Groundwater Application Review Summary Form

Application # G- 19264

A. GENERAL INFORMATION: Applicant's Name: **South Gilliam County Cemetery District** County: **Gilliam**

A2. Proposed use Irrigation of Cemetery Seasonality: March 1 – October 31

Cross-Section

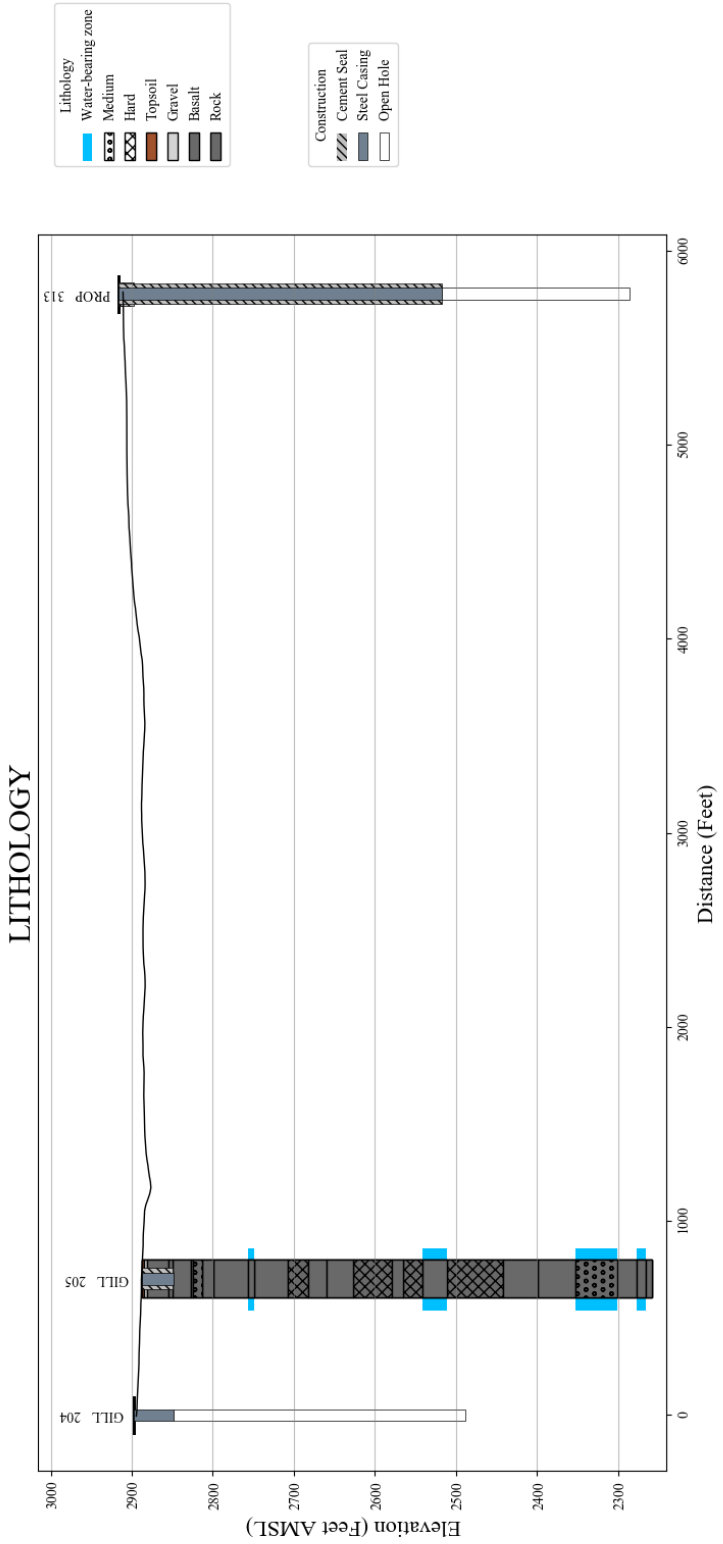
Basis for aquifer hydraulic connection evaluation: Local reach of Dry Fork Hay Creek is not perennial within 1 mile of the proposed POA. Additionally, the proposed POA will produce from water-bearing zones approximately from 2520 feet elev or below (See Cross Section)

Well Statistics

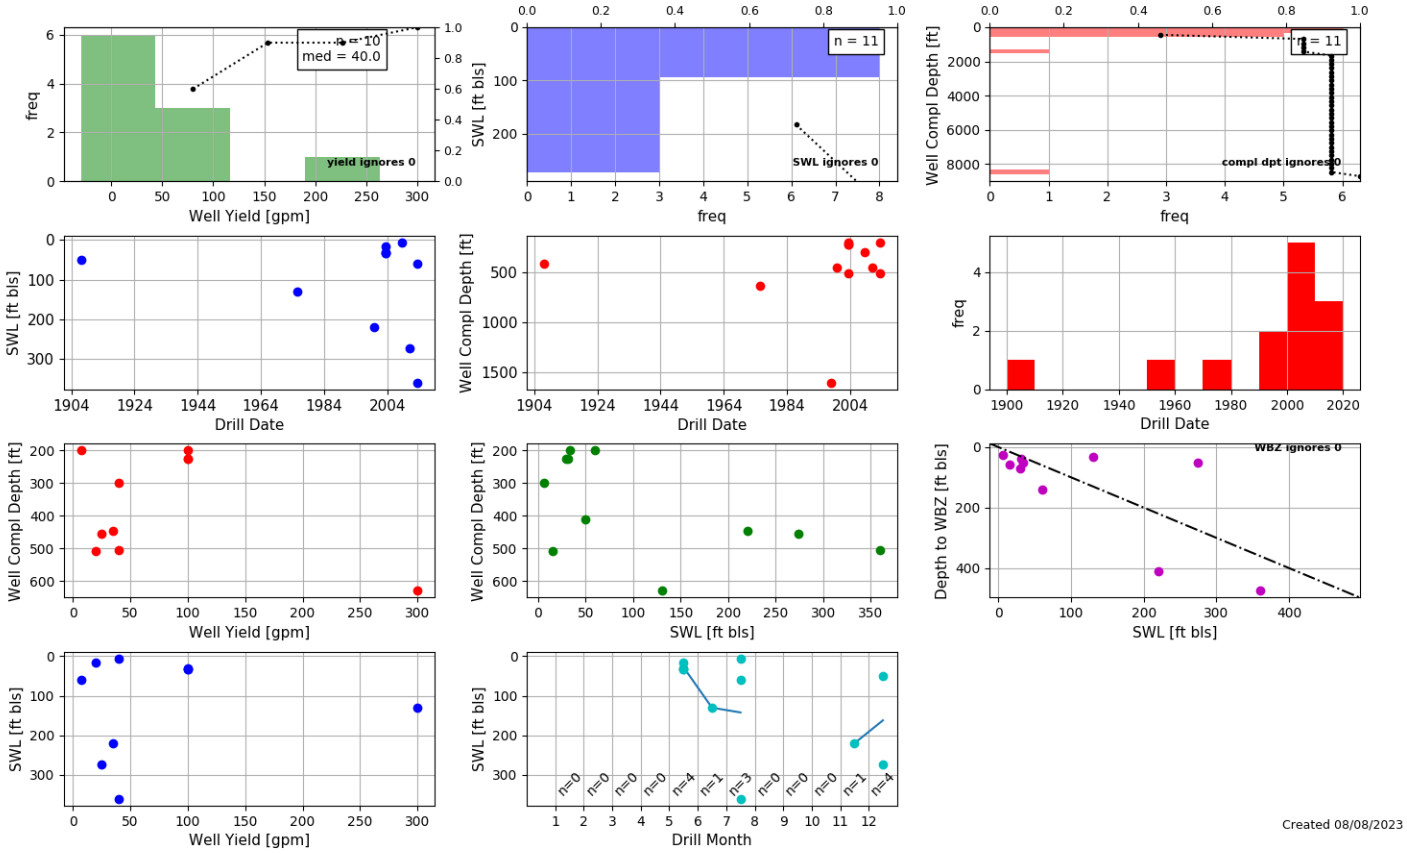
Well statistics for nearby wells indicate well yields range from 0 to 260 gallons per minute (gpm), and the median yield is approximately 40 gpom. (see attached Well Statistics). As a result, the requested rate of 60 gpm (0.13 cfs) should be within the capacity of the resource, if properly conditioned.
